RE: Combined Sewer Solids Separation Facility  
Phase 17 Segment 2  
Wastewater Reclamation Authority  
Des Moines, Iowa  
Wastewater Facility No.: 6-77-27-0-01  
IDNR Project No.: S2007-0268  
SRF No.: CS1920458 01

Subj: Variance Request from Iowa Administrative Code 567-64.2(3)e

**VARIANCE REQUEST**  
**Iowa Department of Natural Resources**

RE: Wastewater Reclamation Authority, City of Des Moines, Iowa  
Combined Sewer Solids Separation Facility  
Variance Request

WRA CSSSF Site Separation - Dean's Lake Route

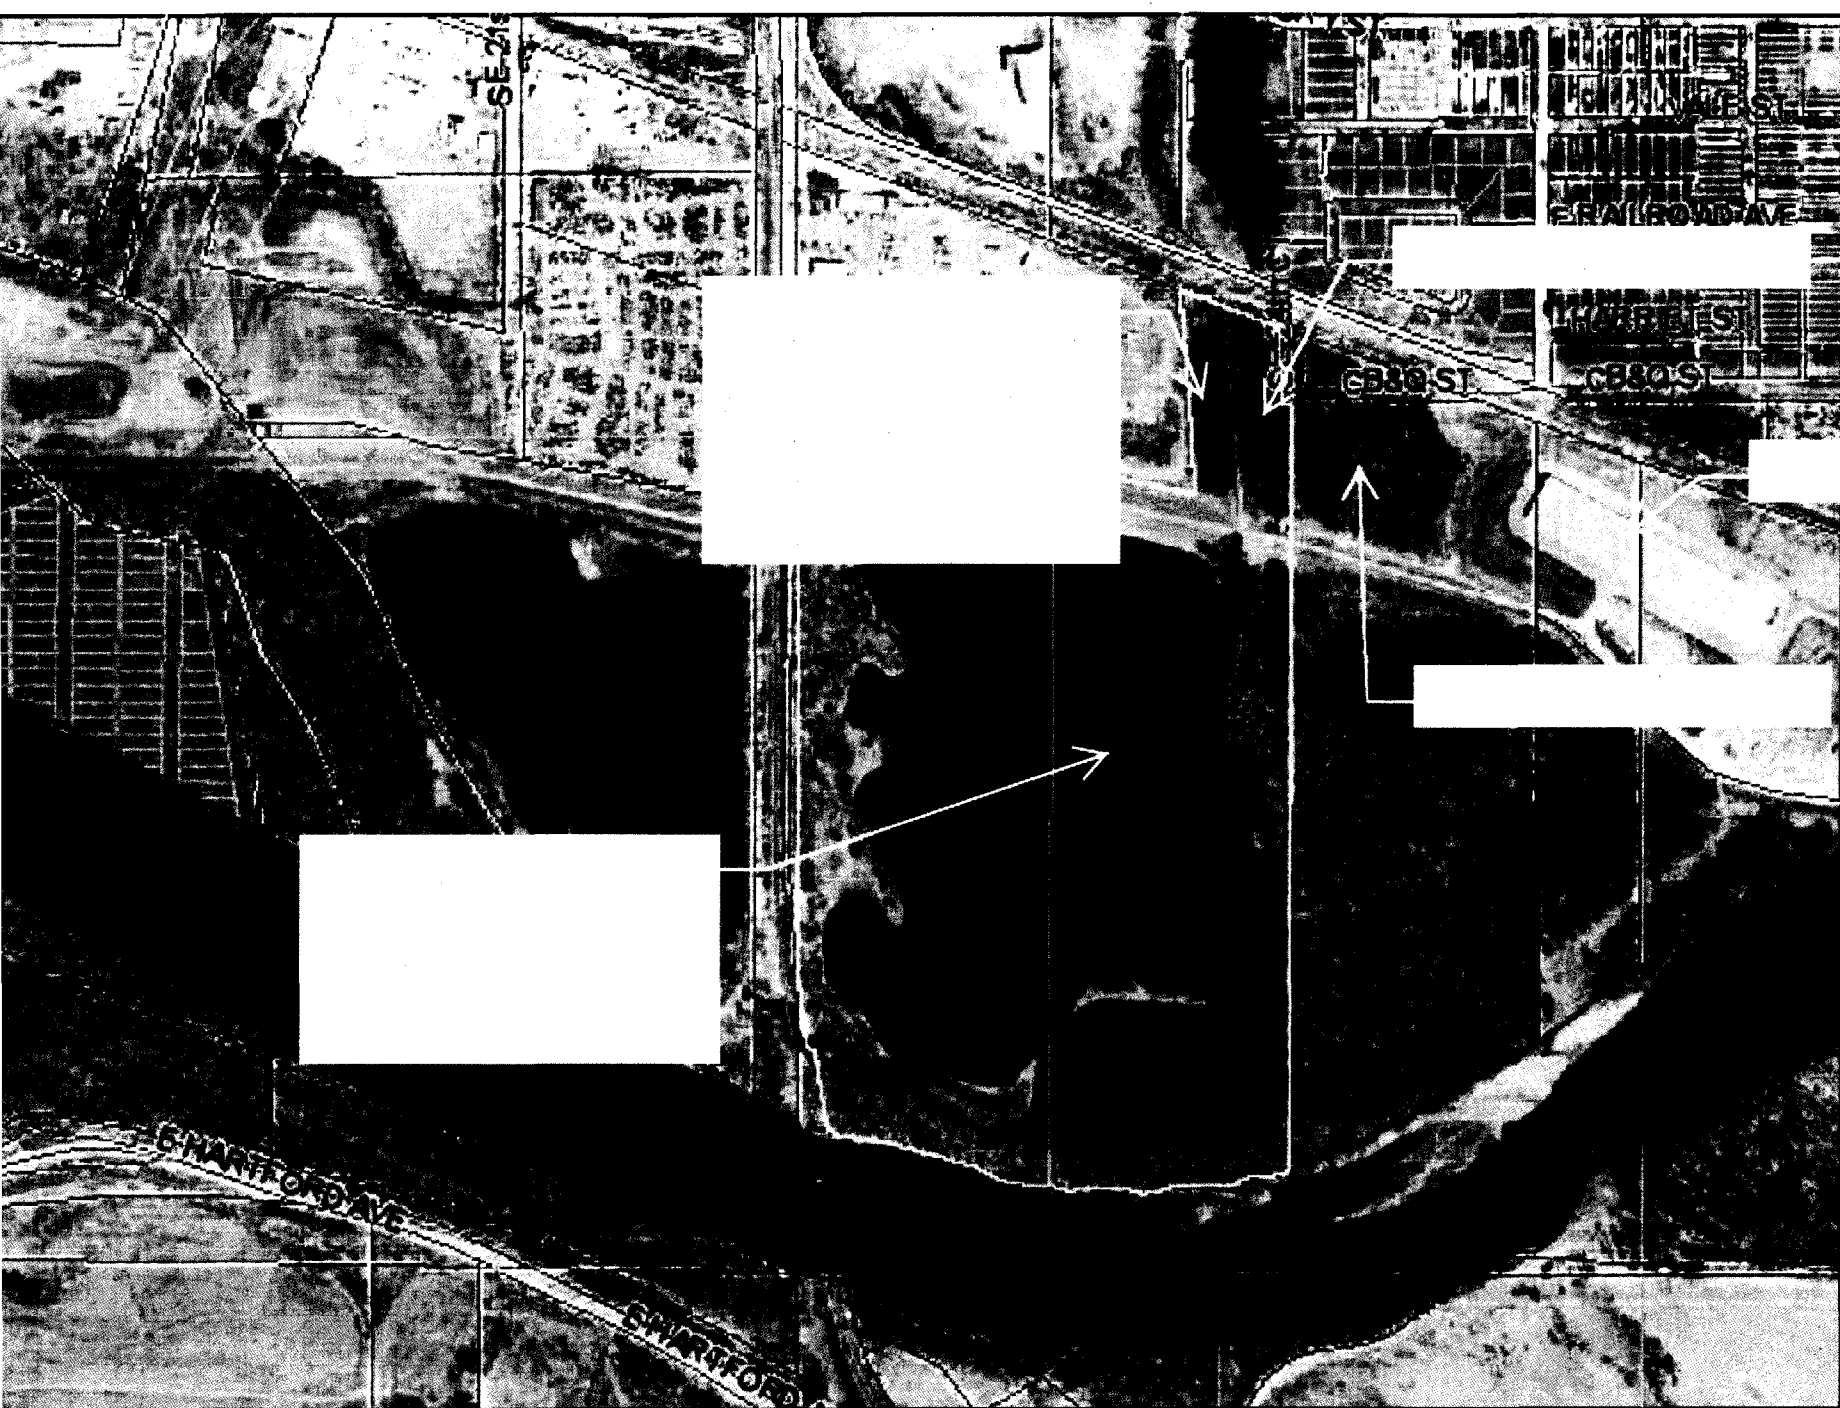
- The gravel pit to southwest of the CSSSF lies within the floodway of Des Moines River and on the river side of the flood levee. Staff does not consider this as an impoundment but part of the Des Moines River.

- Dean Lake is a series of impoundments running from north to south discharging into the Des Moines River. USGS topo map shows the affected part of Dean Lake to be intermittent.

| FIGURE | 1       |

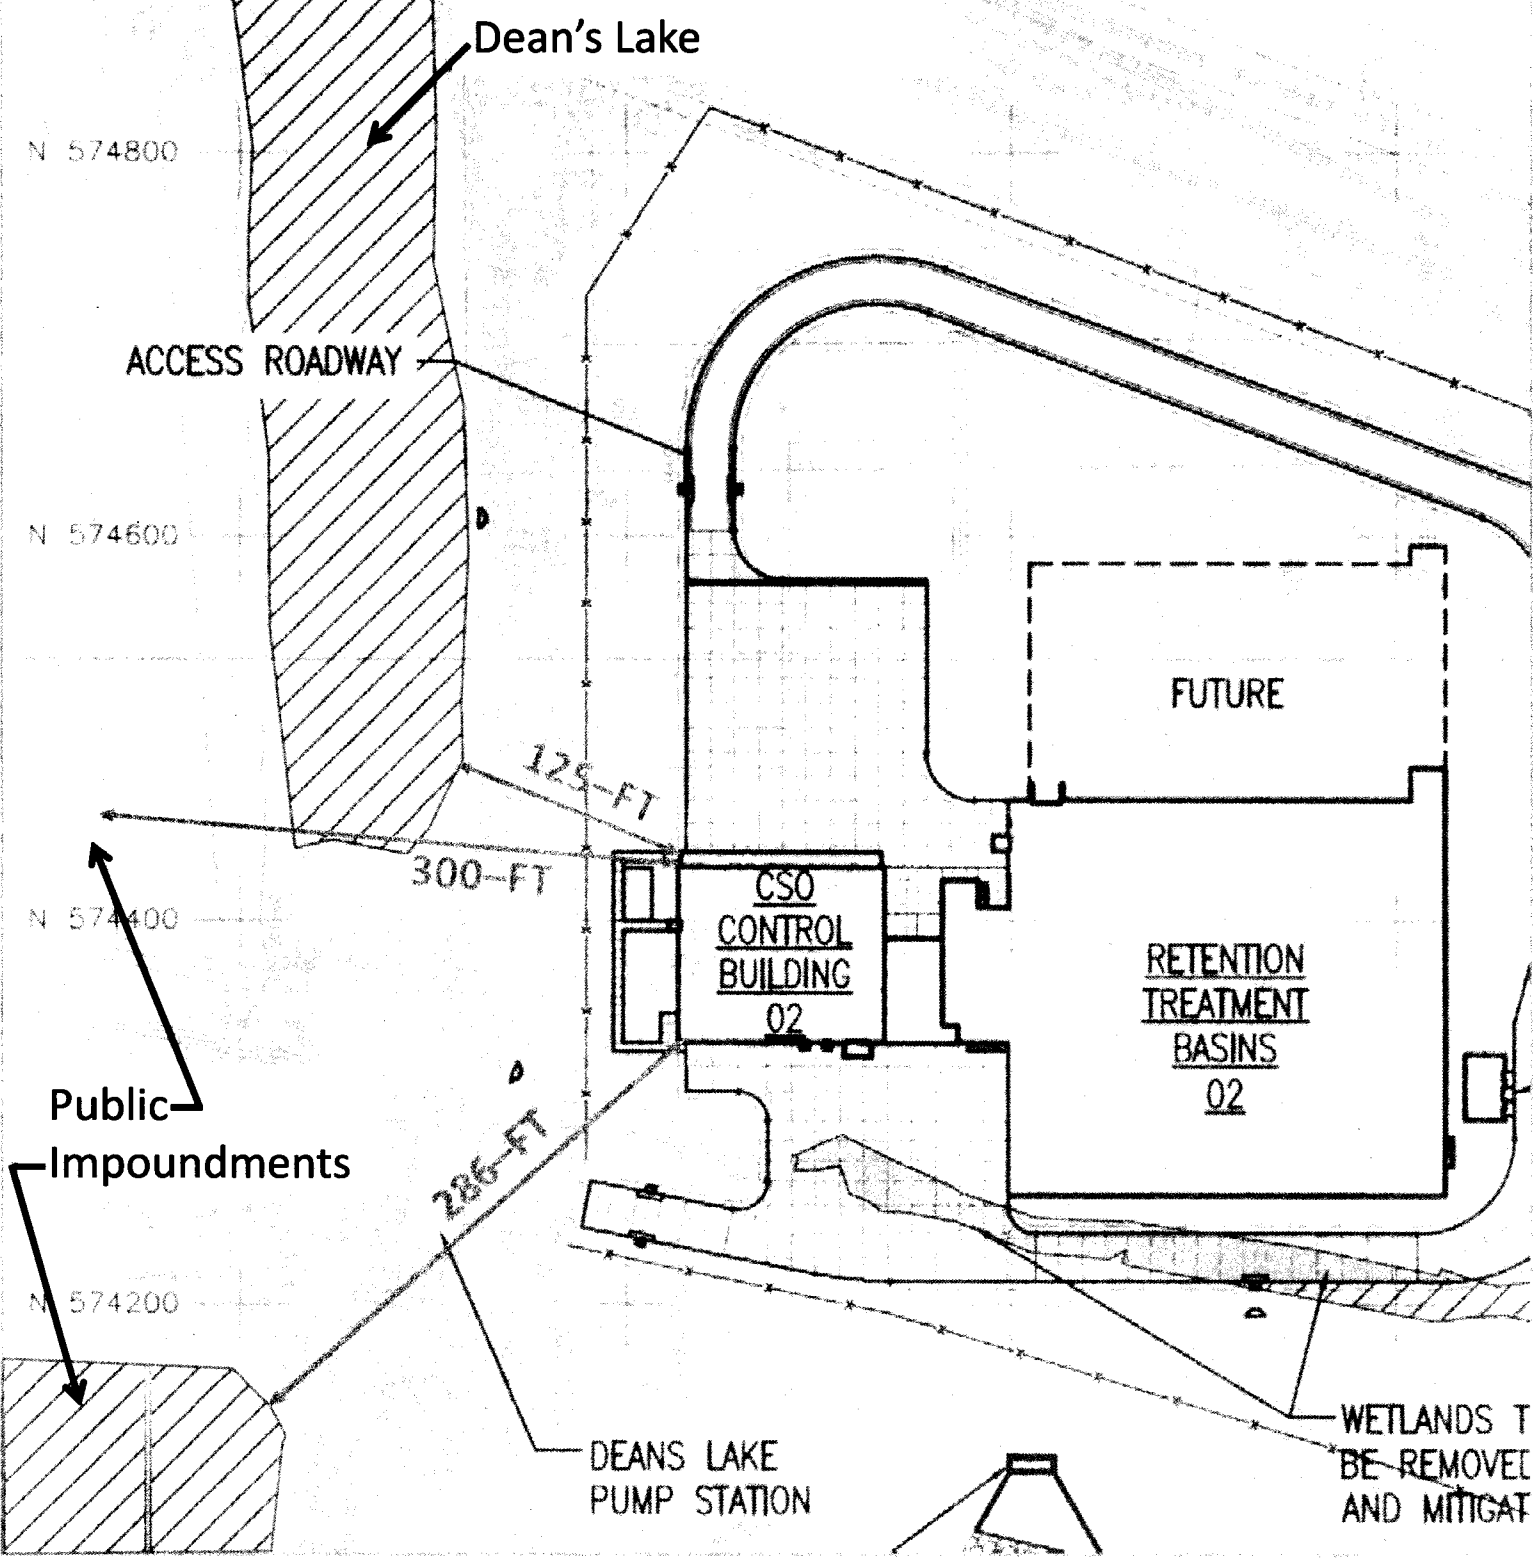
A variance is requested to locate the Combined Sewer Solids Separation Facility (CSSSF) within 400 feet of the Dean's Lake and the two public impoundments, one west of and one southwest of the facility as shown on Figure 1, attached. The following information is presented for your review and concurrence:

After careful and thorough consideration, the Department has approved your July 19, 2010 request for a variance from Iowa Administrative Code 567-64.2(3)e which requires the separation distance of 400 feet between the proposed facility and lakes and impoundments.
